Access Compliance Report

Public Rights-of-Way

(Curb Ramps)

Intersection ID: 2454	Main Street: CLARKE_CREEK_PY	Cross Street: MILLSTREAM_RIDGE_DR	Location: S
ADA ID: F7956C98F41E	Ramp Type: PerpDiag	Initial Pass/Fail: Fail	Overall Compliance: No
Severity Score: 21.25			
Codes/Mitigation Info/Possible Solution		Field Measurements/Component Compliance

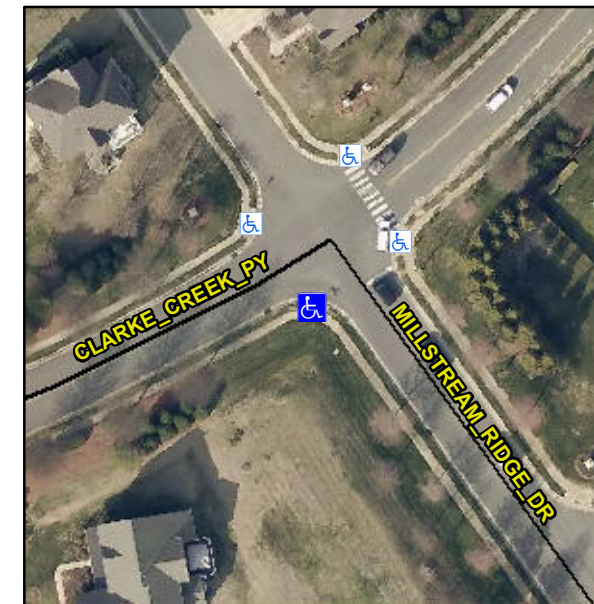
Not Found, R304.5.1, R304.5.3

Compliance	Description	Data	Compliance	Description	Data
N/A	Ramp Length (in)	53.0	Yes	Ramp Slope (%)	6.8
No	Ramp Width (in)	43.0	No	Ramp XSlope (%)	6.5
N/A	Flare Type LT	N/A	N/A	Flare Type RT	N/A
N/A	Flare Slope LT (%)	N/A	N/A	Flare Slope RT (%)	N/A
N/A	Flare Traversable LT?	N/A	N/A	Flare Traversable RT?	N/A
N/A	Landing Length (in)	N/A	N/A	DWS Provided?	N/A
N/A	Landing Width (in)	N/A	N/A	DWS Contrast?	N/A
N/A	Landing Slope (%)	N/A	N/A	DWS Length (in)	N/A
N/A	Landing X Slope (%)	N/A	N/A	DWS Full Width?	N/A
N/A	Landing Curb? (Y/N)	N/A	N/A	DWS Offset (in)	N/A
N/A	Shared Landing?	N/A			
N/A	Gutter Ponding?	N/A	N/A	Gutter Slope (%)	N/A
N/A	Gutter Lip Ht (in)	1.0	N/A	Gutter X Slope (%)	N/A
N/A	Painted X Walk1?	No	N/A	Painted X Walk2?	No
	X Walk 1 Direction	To NE		X Walk 2 Direction	To NW
N/A	X Walk 1 Width (in)	N/A	N/A	X Walk 2 Width (in)	N/A
	X Walk 1 Slope (%)	3.6		X Walk 2 Slope (%)	5.4
	X Walk 1 X Slope (%)	7.2		X Walk 2 X Slope (%)	3.6

Remove & Replace Curb Ramp With Two New Directional Ramps or Equivalent.
